PROJECT REVIEW COMMITTEE RECOMMENDATIONS DRAFT

#SP-014-11-12

1500 South Plymouth Avenue, Brooks Landing Phase II

November 2, 2011, 4:00PM

(2)

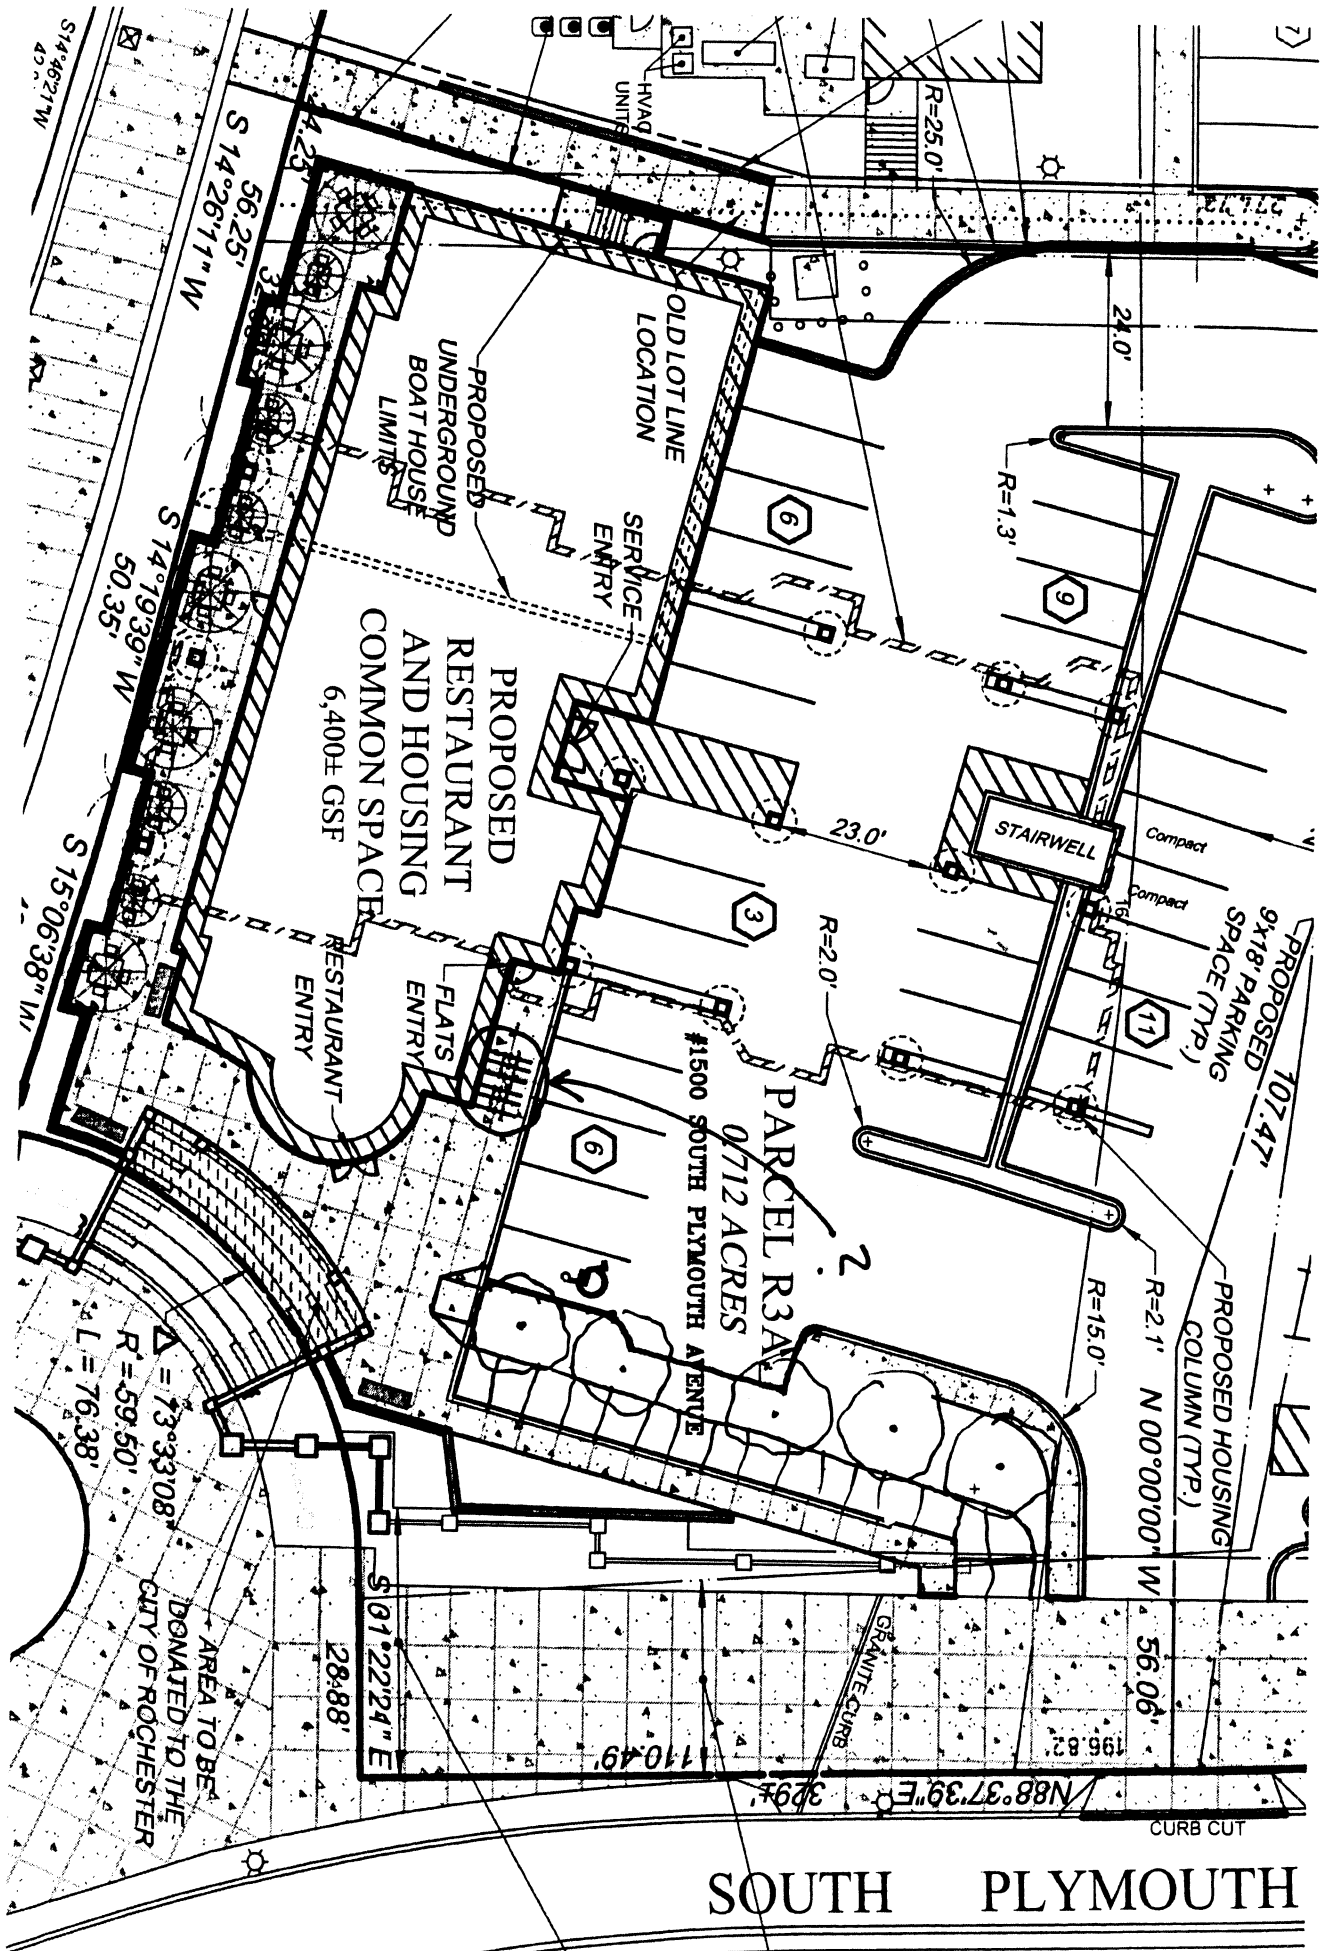
1. Site
 - a. Narrow drive-through queuing area from two to one lane, to reduce the impact on the public pedestrian easement (see sketch 2).
 - b. Eliminate four northern-most parking spaces, adjacent to South Plymouth Avenue, to provide for a more substantial forecourt/pedestrian entry area and mitigate the impact of the placement of parking between the building and the street (see sketch 1).
 - c. Clarify placement of what appear to be bike racks in the sidewalk path just to the north of the student housing entry door (see sketch 1). Given the site of this building on the Genesee Riverway Trail and the fact that the intended residents will be students, generous, secure, sheltered bike storage should be provided within the building.
2. Credit Union
 - a. Reconfigure massing to place the taller portion of the building and main

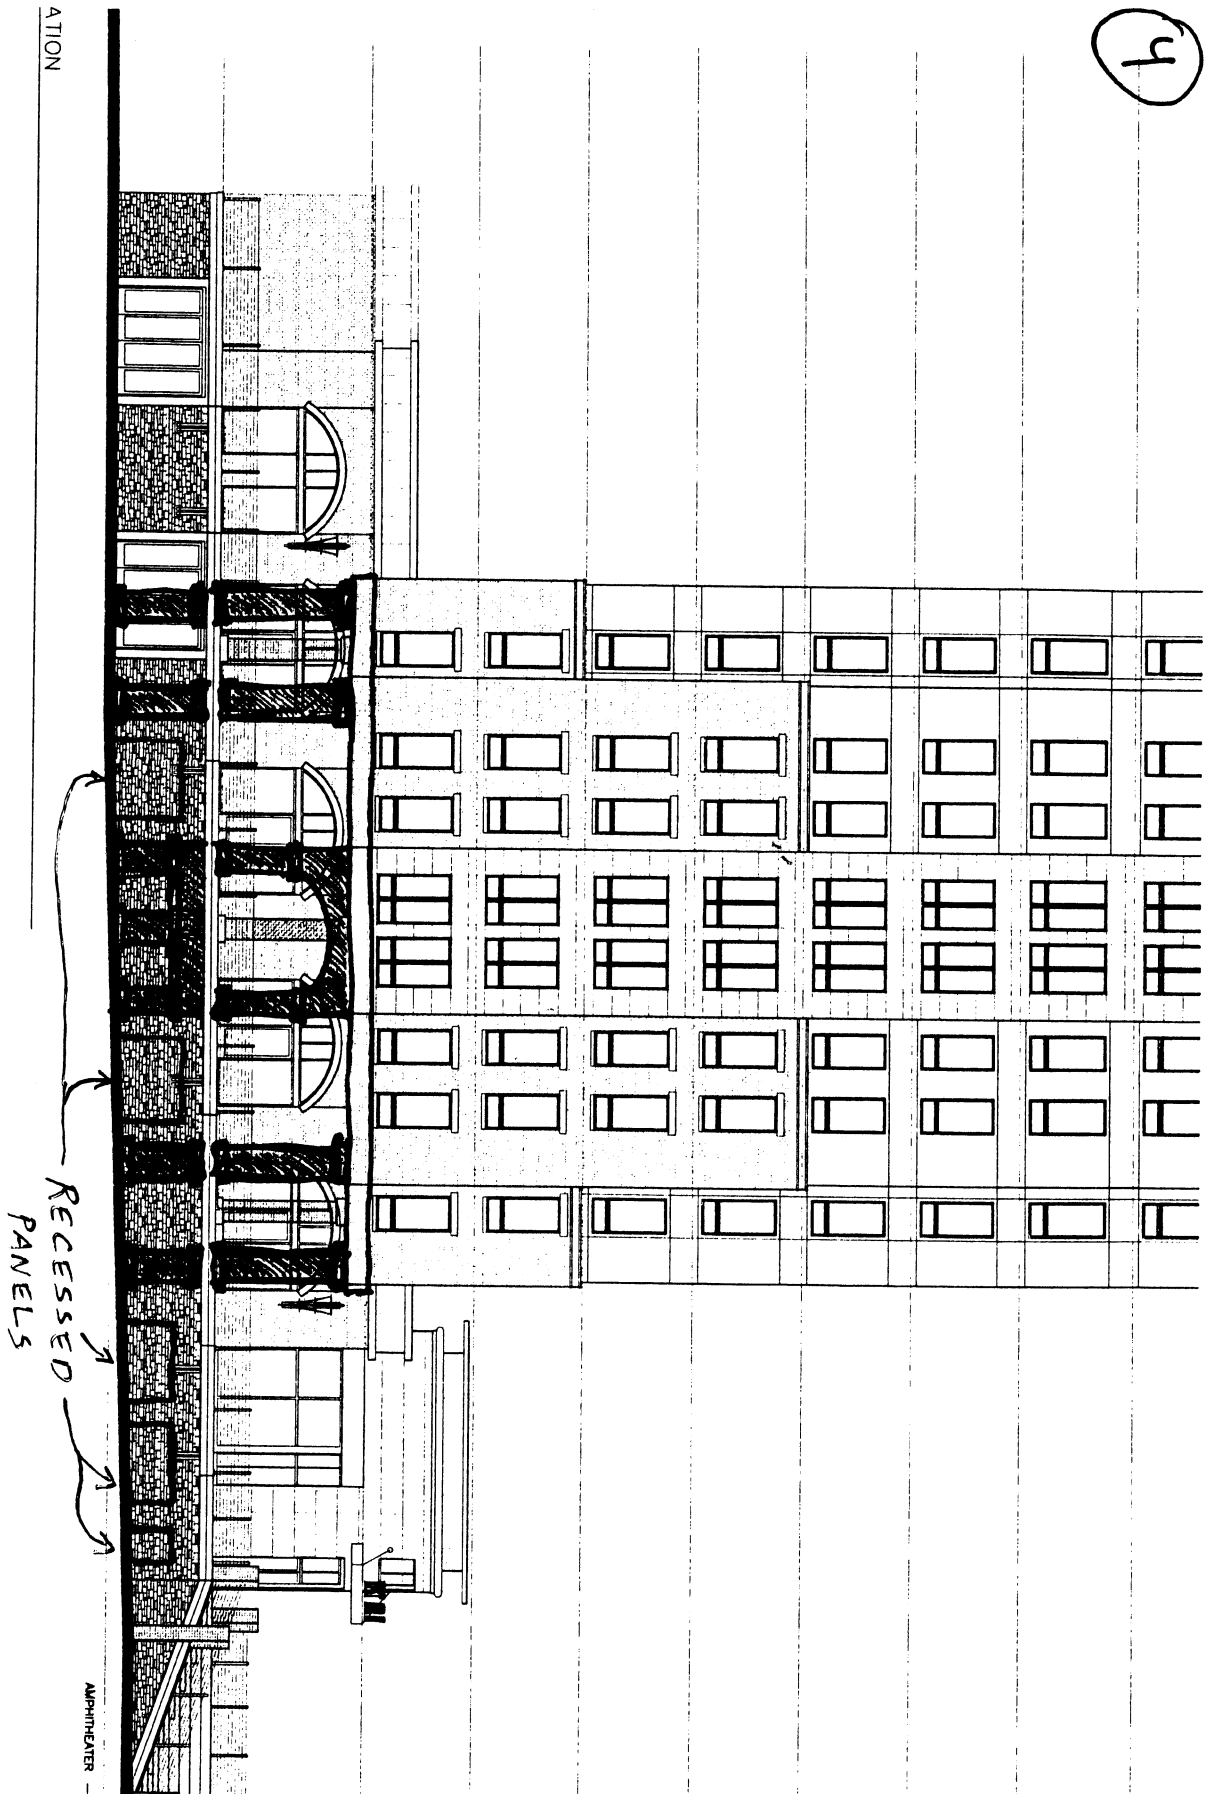
- b. The vertical elements of the student housing above the first floor should be carried downward to align with elements and window openings for the restaurant level and boathouse and wall articulation on the ground floor level (see sketches 3 and 4)

- c. Columns at restaurant level need to be wider, more visually substantial
 4. Mixed use building, east façade ground floor:
 - a. Articulate blank wall at northern portion of building with shallow recessed panels and projecting pilasters integrated into the masonry (see sketch 4)

6. Mixed use building, façade general
 - a. Reconfigure cladding materials in a different pattern that compliments the form of the building (see sketch 5)

- c. Articulate flat roof plane with some sort of substantial projecting elements (elevator penthouse, decorative gable, etc.)
 8. The proposed materials (brick and EFIS), as currently arranged on the façades, do not mitigate the impact of the additional height of the building (see sketch 5).
